## Radio Environment within Factories

**Figure 13** Layout in factory for which measurement of RSSI is recorded

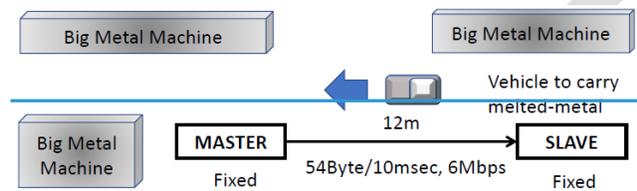
The layout of the environment for which measurements are made is shown in the ~~Figure 1~~Figure Master and slave transceivers were located ~~in LOS condition and there was no blockage by a vehicle, human body and any other objects in the line between the master and slave transceivers~~ during measurement.

Figure 24 RSSI Fluctuation in Factory (LOS)

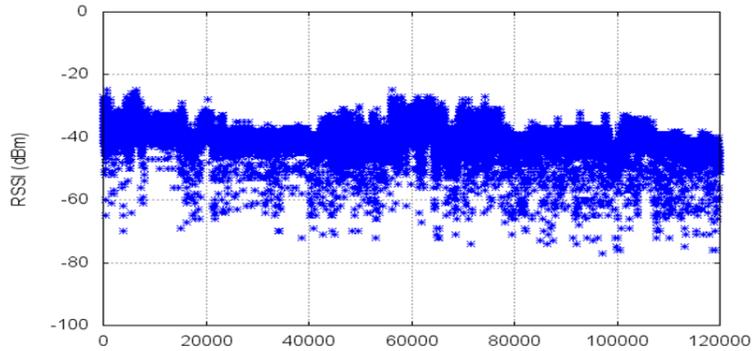
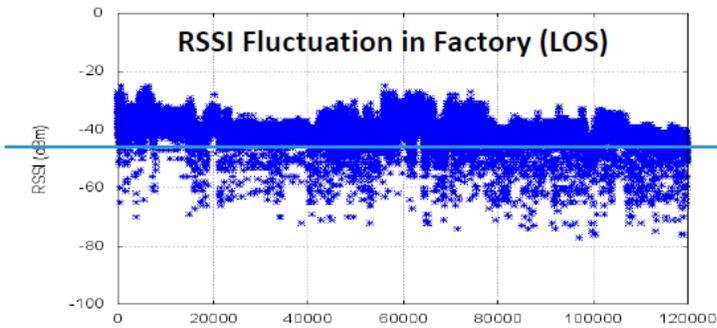
Commented [m3]: 145:E delete "in LOS condition" (accepted) "LOS" appears no longer in the section.

Commented [m5]: delete "in LOS condition (same as 145E) and add "for this layout"

Commented [m6]: 145:E adding words to explain Seq. number (Proposed)

Commented [m7]: delete "in LOS condition (same as 145E)"

The observed RSSI measurement ~~in LOS condition for this layout~~ is shown in ~~Figure 2~~Figure 4 ~~54Byte was sent at each sequential(Seq) number with 10-msec separation at a data rate of 6Mbps.~~

Figure 35 Measured noise spectral density within 920MHz band

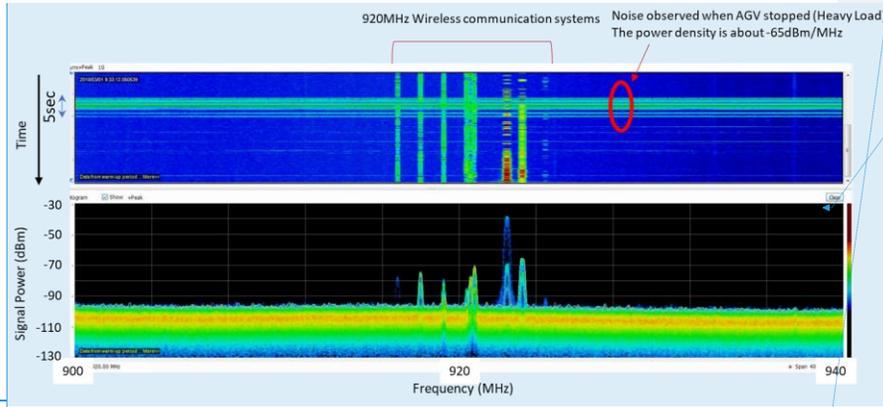
Commented [m13]: (Proposed) Replace figures to resolve all comments.

155:T revise to more comprehensive figure

156:T adding units in the figure 5

157:T Delete 1.9GHz measurement results

Commented [m14]: 154:T adding noise power in the text

The observed noise power was  $-65\text{dBm/MHz}$  which were above the receiving sensitivity for the 920MHz wireless systems. In the under 1 GHz band, the noise appears to cause problems for the communication with sensing systems using 920MHz band wireless communications. In the 1.9 GHz band, the noise appears to cause problems for the communication with particular machines as well as problem for using the 1.9GHz band for internal telephone system.

**Figure 47** Wireless signals with coexistence of different wireless technologies. The x- and horizontal axes show frequency (Hz) and time, and color shows signal strength in a bar on the right hand side.

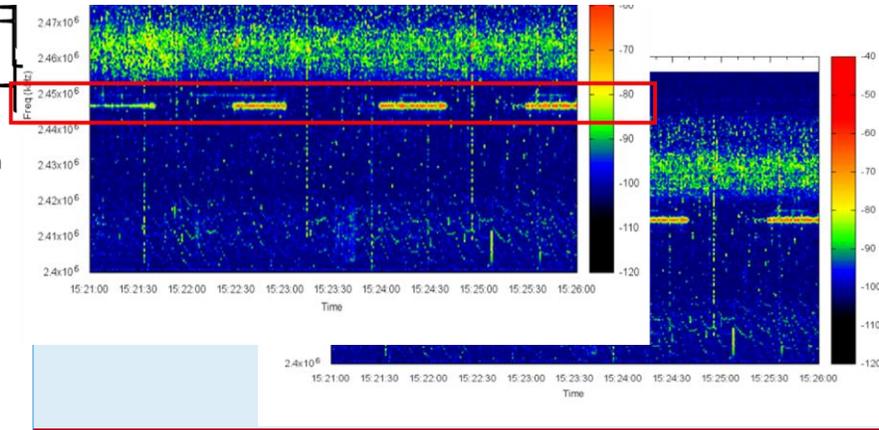
Commented [i17R16]: Issues of this section should cause from co-existence of multiple "uncoordinated and independent systems" in factory site. However this example shows monolithic system in factory site. Because of that, this system is not fit as example of this section. Because of that, this example is deleted from here.
